KENZIE H&H HOMES - GARAGE LEFT

PLAN REVISIONS

BUYER MARKED

KENZIE
H&H HOMES

FRONT ELEVATION
SCALE 1/4" = 1'-0"

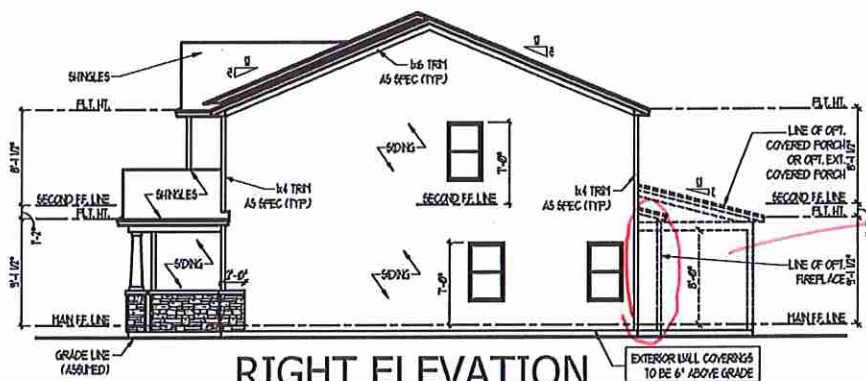
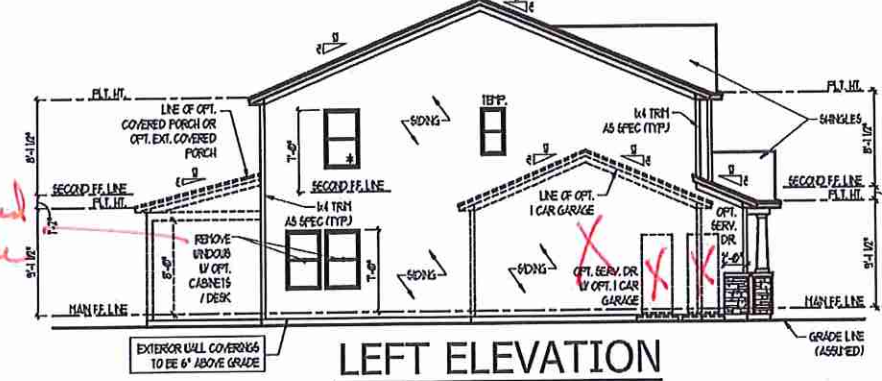
See Ranch style garage door
STONE
2 panel square front door
no grid

All windows are 4/1 grid pattern

FIRST FLOOR ELECTRICAL PLAN

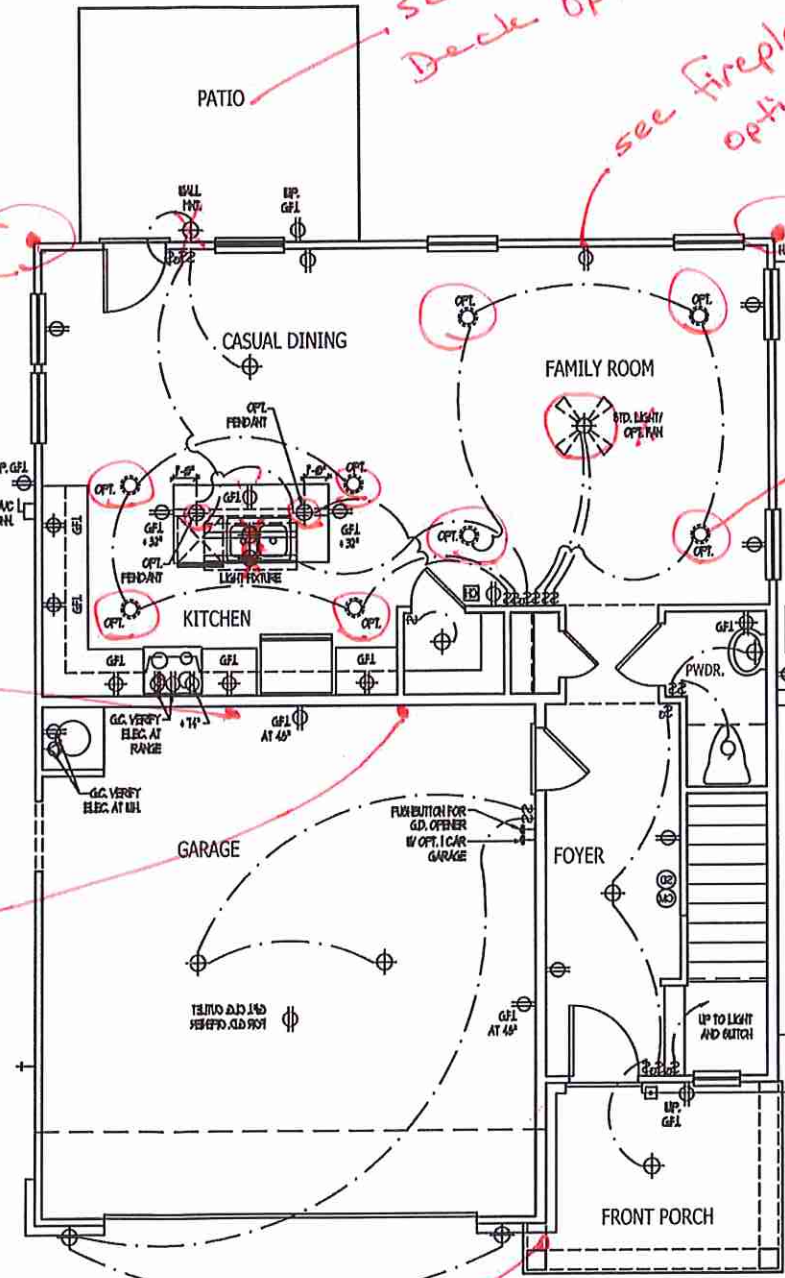
see covered Deck Option

see fireplace option

Flood light

Flood light

4 Recessed cans w/ Dimmer

Standard 110V R

dedicated 110V R

FIRST FLOOR ELECTRICAL PLAN OPTIONS

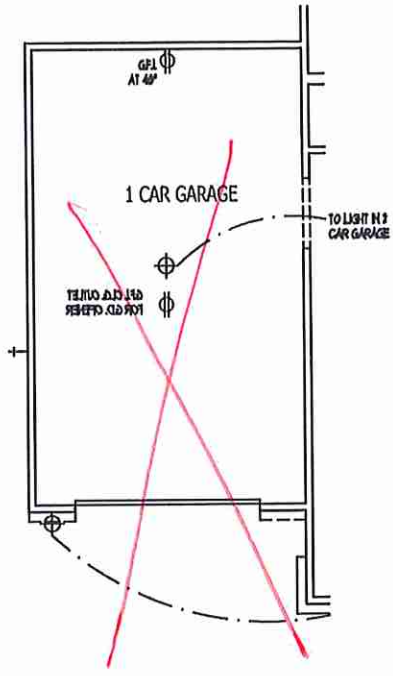
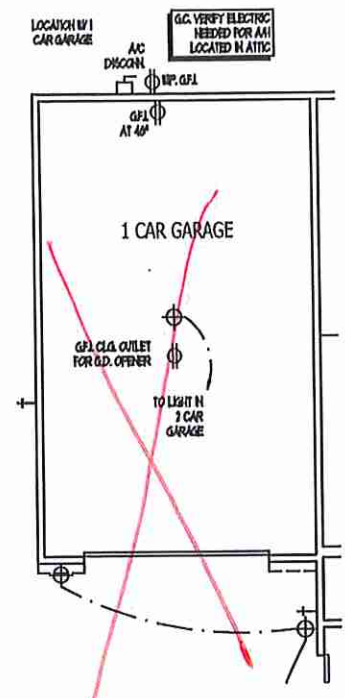
*light standard
prewire for
ceiling fan*

SECOND FLOOR ELECTRICAL PLAN OPTIONS

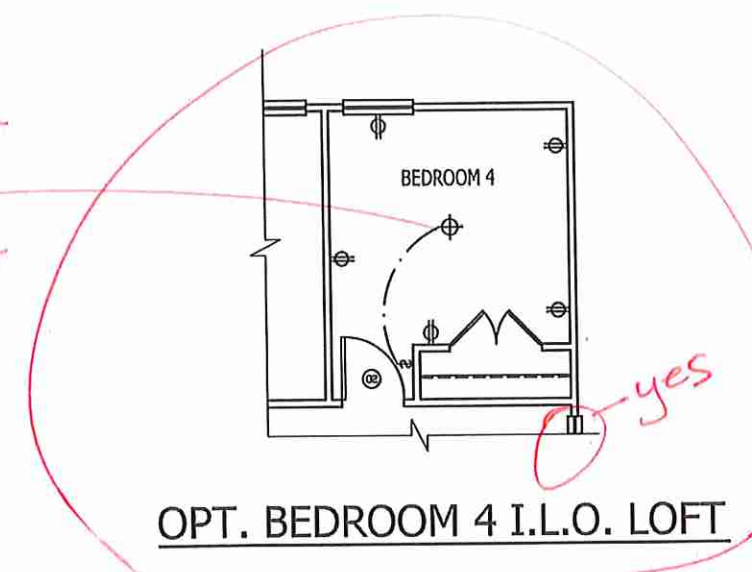
*light standard
provide for
fan/light*

CRAWL SPACE FOUNDATION PLAN
 ELEVATIONS 'A1' & 'A2'

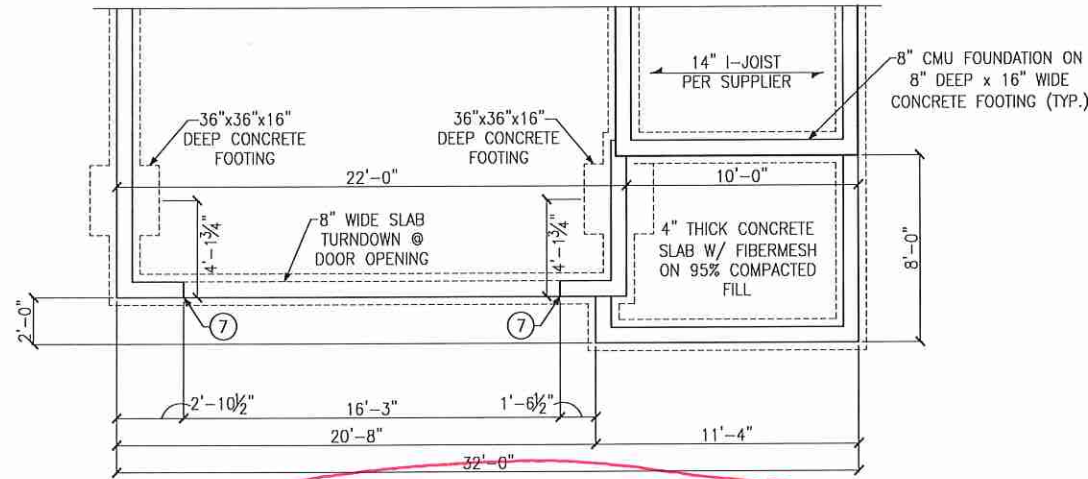
see elevation B2

~~PARTIAL FRAMING PLAN
 OPT. SIDE LOAD GARAGE
 ELEVATIONS 'B1' & 'B2'~~

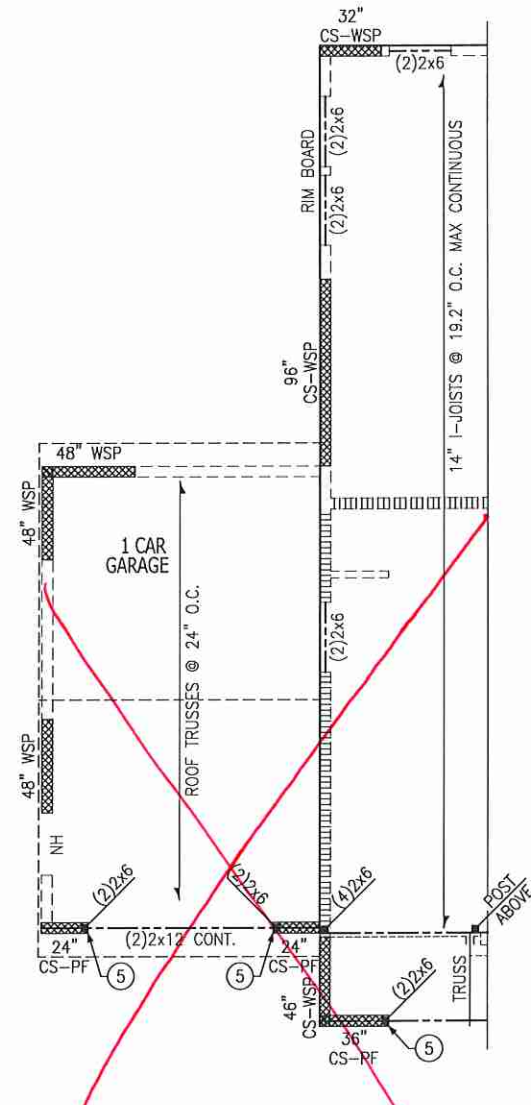
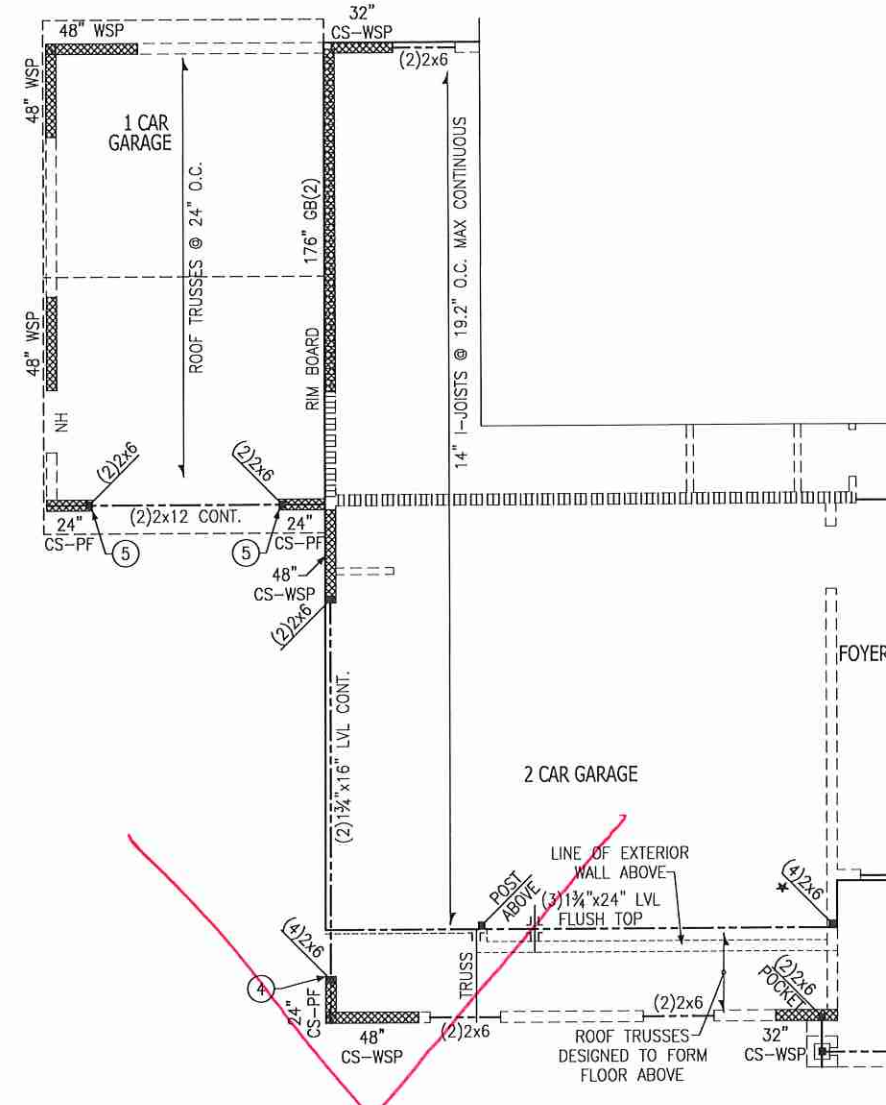
~~PARTIAL FRAMING PLAN
 OPT. 1 CAR GARAGE
 ELEVATIONS 'B1' & 'B2'~~

~~PARTIAL FRAMING PLAN
 OPT. 3-CAR SWING IN CARRIAGE GARAGE
 ELEVATIONS 'B1' & 'B2'~~
